**RESOLUTION SETTING HEARING ON REQUEST FROM
QUIK TRIP CORPORATION TO REZONE PROPERTY LOCATED AT
1515 EAST GRAND AVENUE AND 1522 CAPITOL AVENUE**

Communication from the City Plan and Zoning Commission advising that at their meeting held September 15, 2016, the following actions were taken regarding requests from Quik Trip Corporation (owner) represented by Michael Talcott (officer) on property located at 1501 & 1515 East Grand Avenue and 1522 Capitol Avenue.

STAFF REPORT TO THE PLANNING COMMISSION

Front Elevation

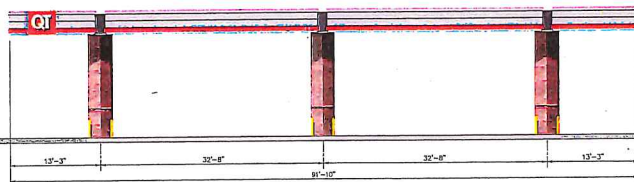
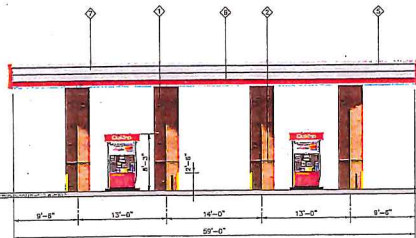
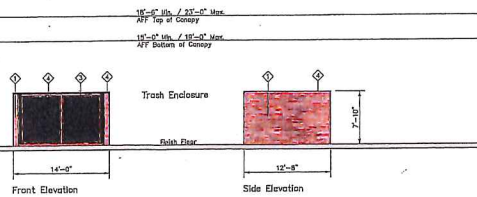
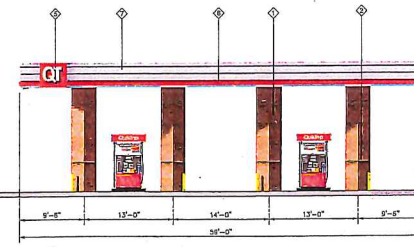
The three primary facades of the proposed building would be sided with brick and porcelain tile and would have aluminum cornices and entrance canopies. The rear façade would be sided with brick with no other detail. Staff recommends that porcelain elements be provided on the rear façade along with cornice design to match the other three facades. This is based on the east side of the building being within public view of East Grand Avenue.

The proposed building design includes wall plane variation and parapet wall height on the three street facing facades.

The proposed building design includes wall plane variation, material variety and varying parapet wall heights on the three street facing facades.
